SUBJECT: Transmittal of Revised Responses to AP1000 DSER Open Items

AP1000 Design Certification Review  
Draft Safety Evaluation Report Open Item Non-Proprietary Responses

**DSER Open Item Number:** 3.8.2.1-1 Revision 2

**DSER Open Item Number:** 19.1.10.1-5 (Response Revision 2)

Figure 19A.2-8-4: Floor Response Spectra of ASB Node at EL. 116.50'

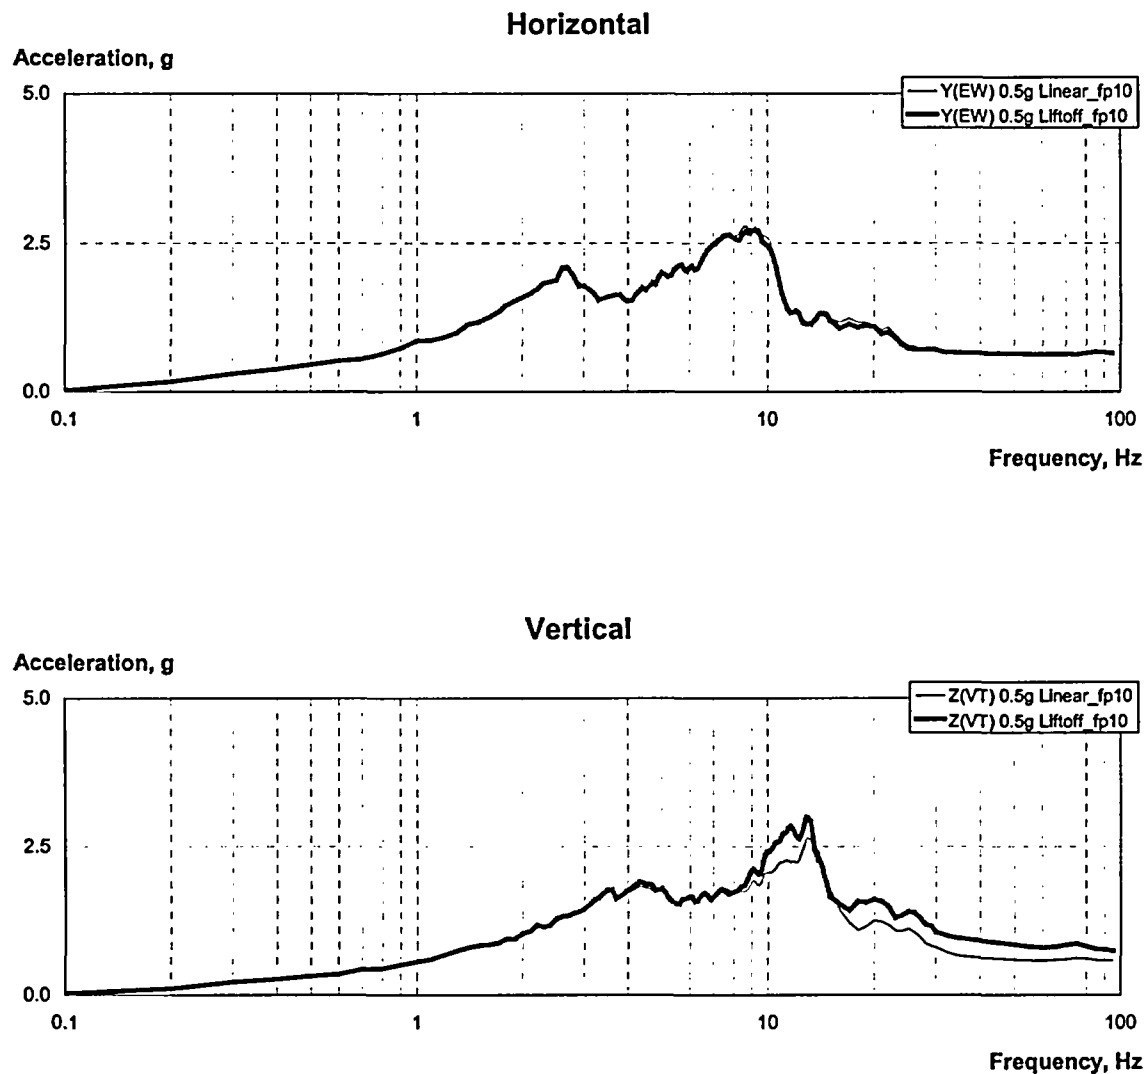
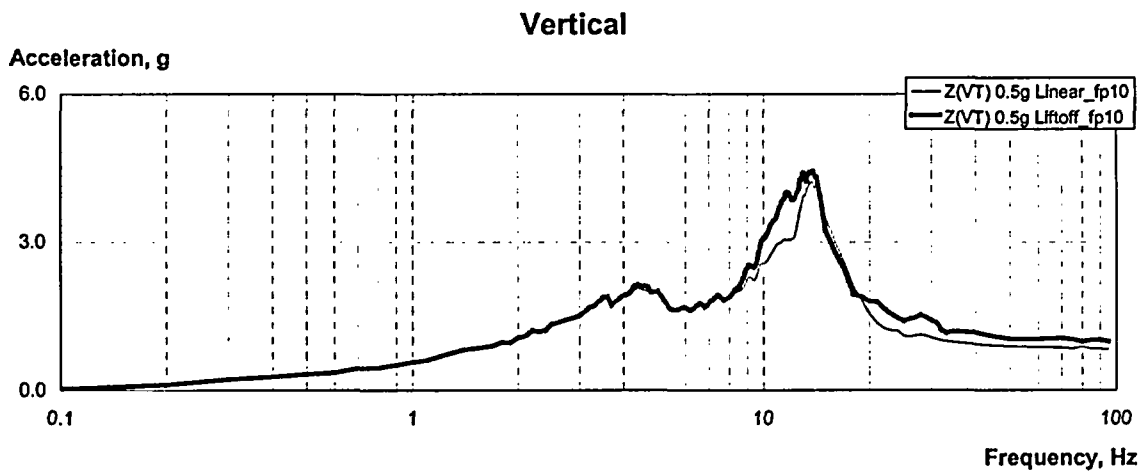
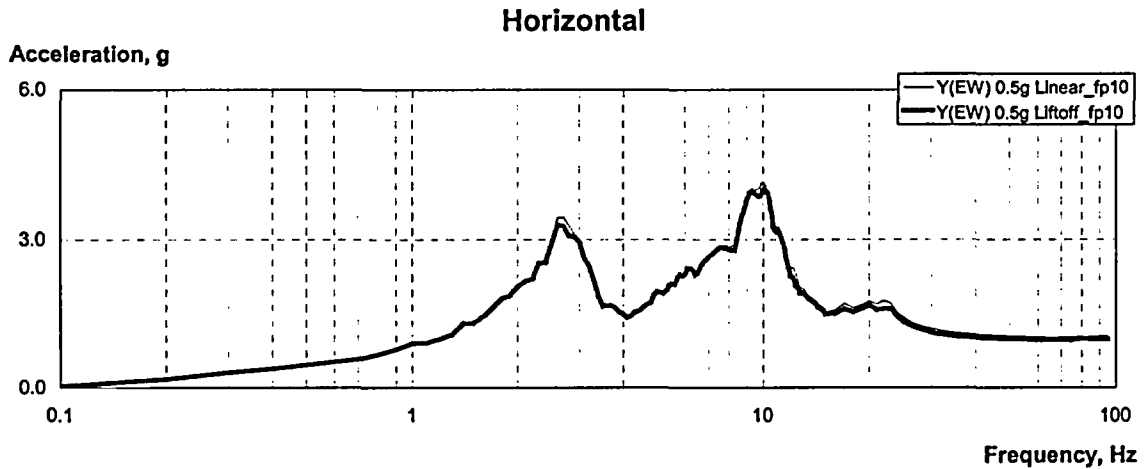
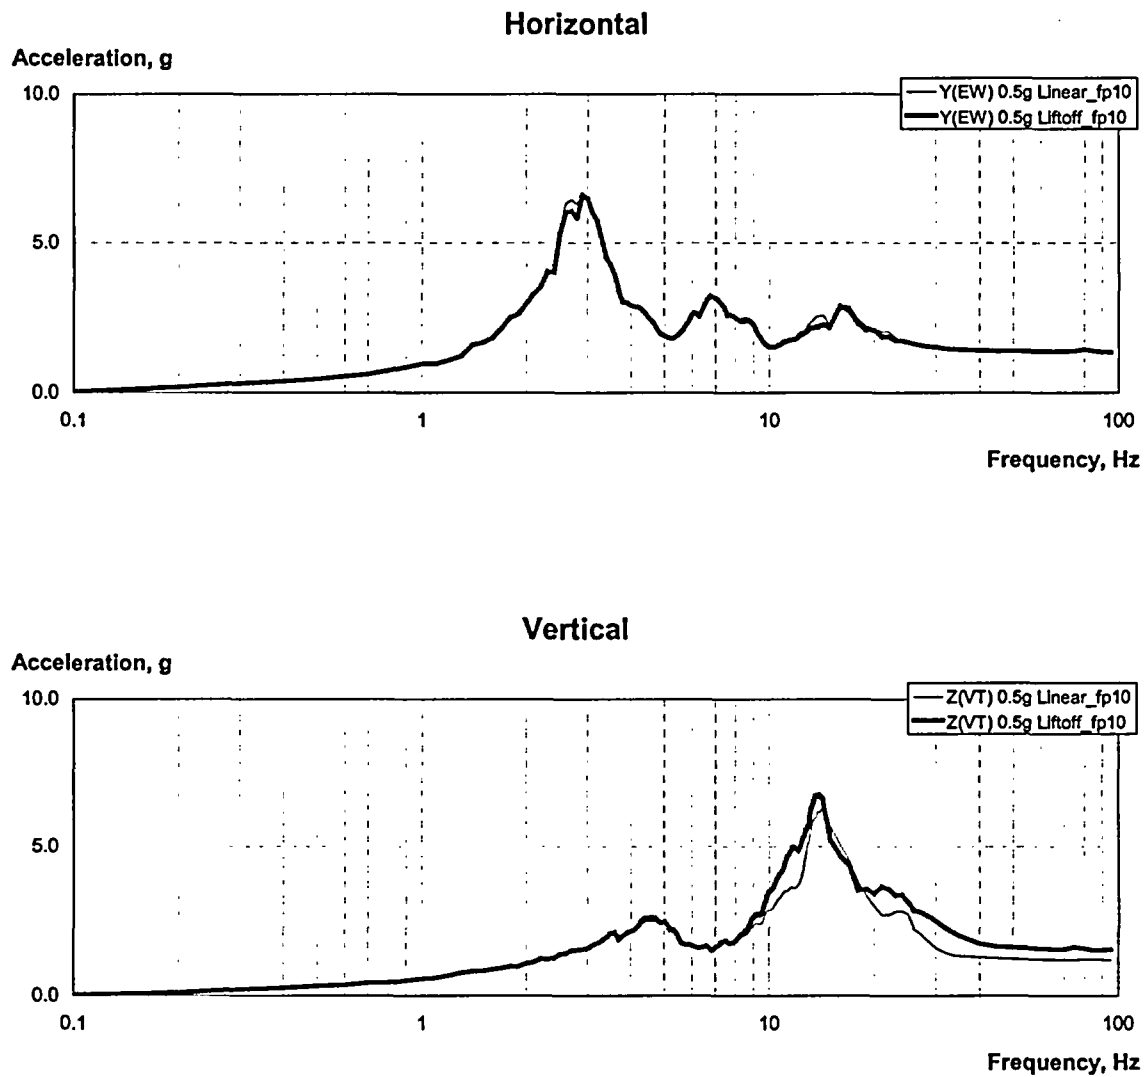
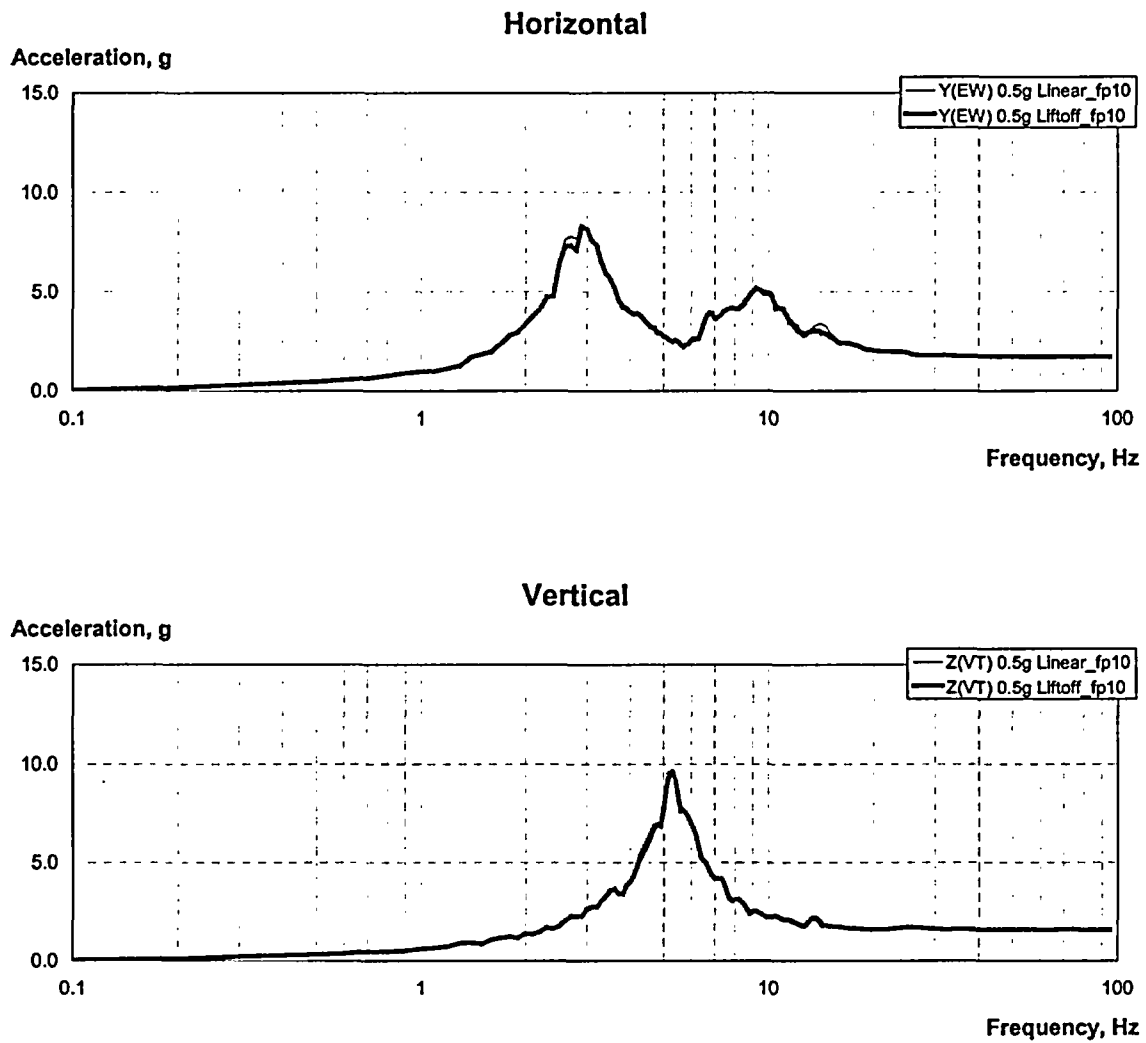
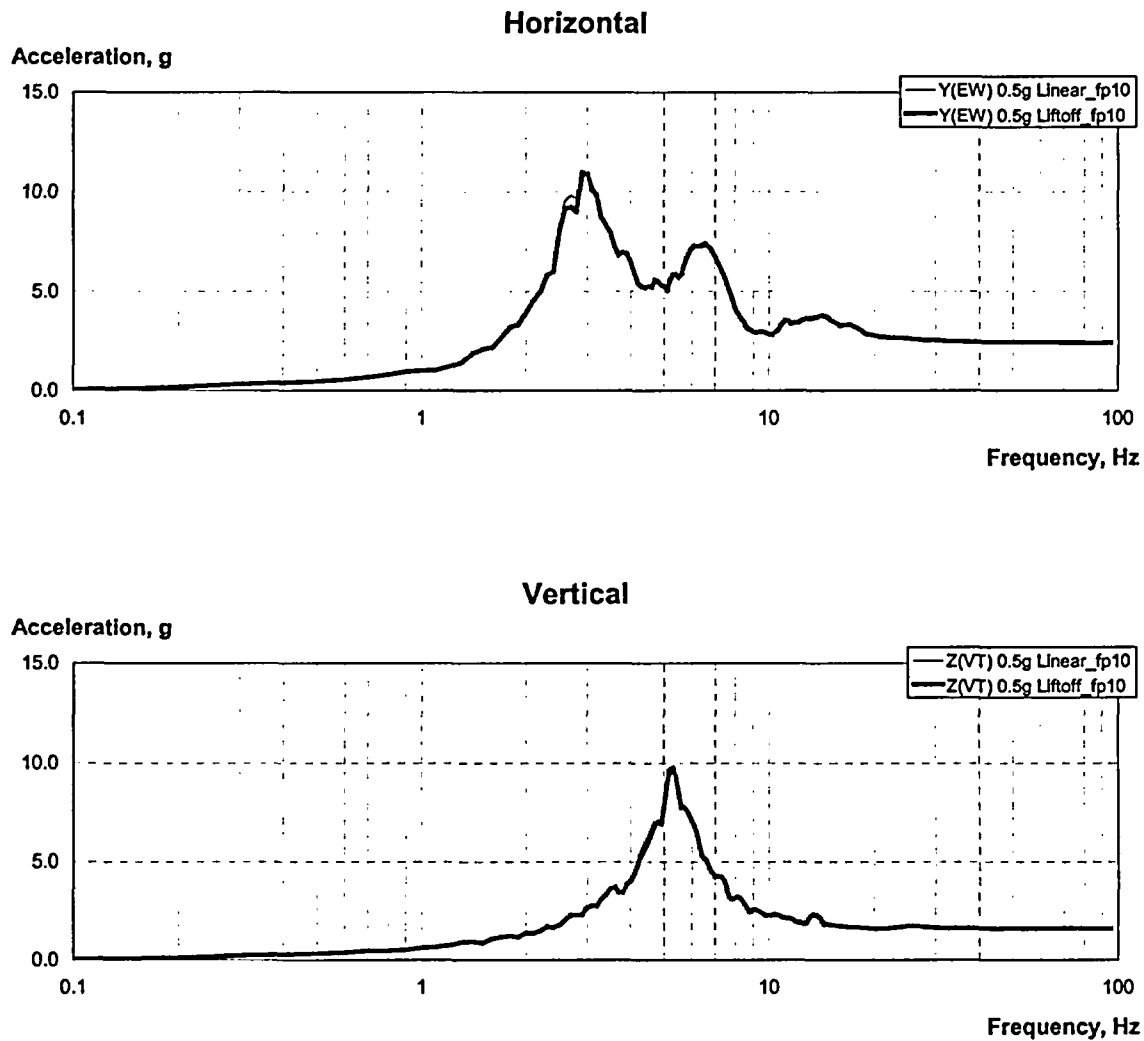
Westinghouse has not adequately justified that the effect of lift off of the nuclear island basemat is not significant in the seismic margin evaluation. The results that are presented in the Revision 1 response may cause the HCLPF values to fall below the review level earthquake of 0.5g. Further, the CIS lift off with the nuclear island basemat uplift may make the seismic response worse. Westinghouse has not presented results from a combined model with liftoff from the CIS and nuclear island basemat to demonstrate that the results are not higher than those presented.

Figures 19A.2-8-4 to 19A.2-8-8 compare the response spectra from the non-linear analyses (with lift-off) against those from linear analyses (no lift-off). The comparison shows that the effect of liftoff on the horizontal seismic response is insignificant. There are small differences in the vertical response spectra in the higher frequency region for the Shield Building cylinder up to elevation 265'. The effects of lift off are much less than in the analyses described in the Revision 1 response.
